MIL-M-28787/173A
AMENDMENT 1
28 April 1993

MILITARY SPECIFICATION

MODULES, STANDARD ELECTRONIC

MULTIPLEXER, DIGITAL, KEY CODE EBE

FIGURE 19. Power supply filter capacitance and input capacitance test circuit for tables XVIII and XIX.

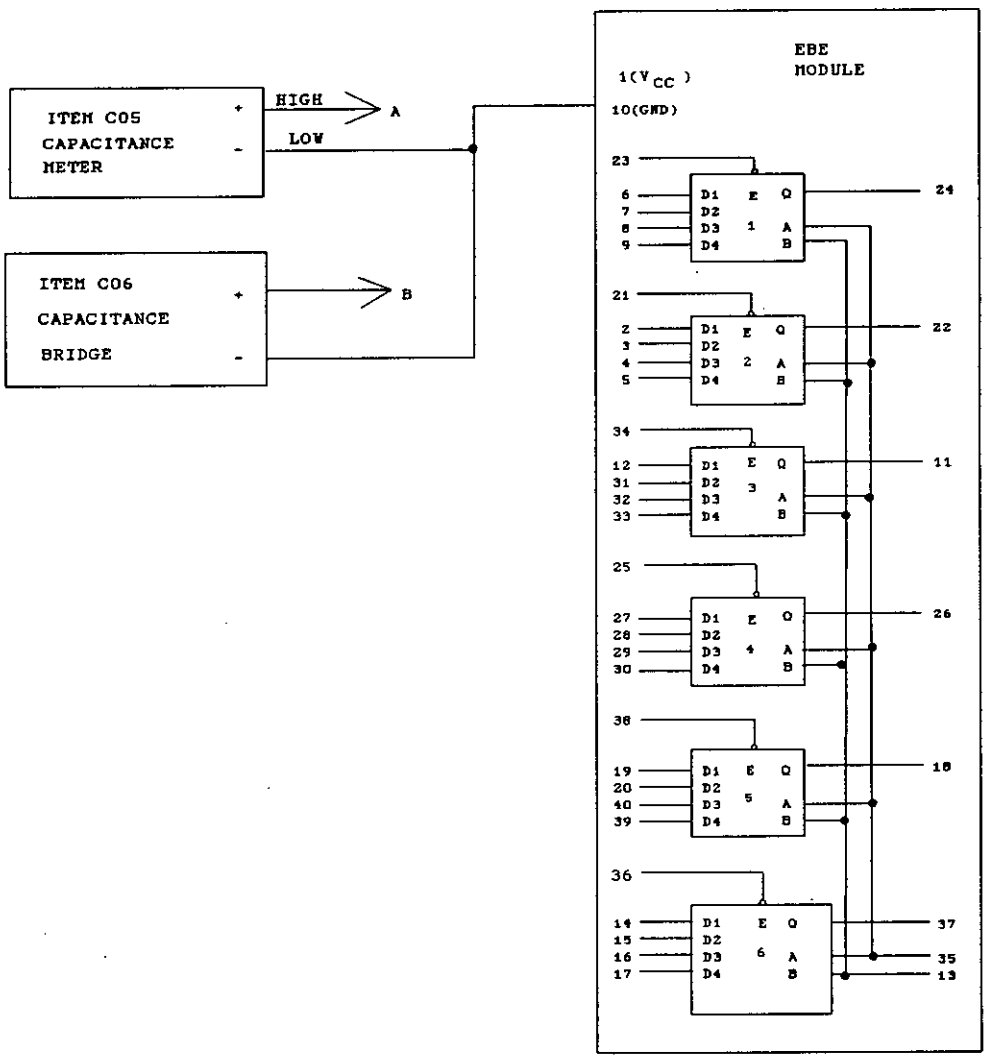
FIGURE 19: Delete and substitute new figure 19 as printed on page 3 of this amendment.

NOTES:
1. Null out the effect of the test leads prior to connecting to the module.
2. Do not attach test connector or wires to any of the module pins other than pin 10 and the pin under test. Stray capacitance added to other pins may affect the readings.
3. Capacitance bridge (C06) setup: Frequency = 1KHz.
   V_{pk} = 0.3V maximum.
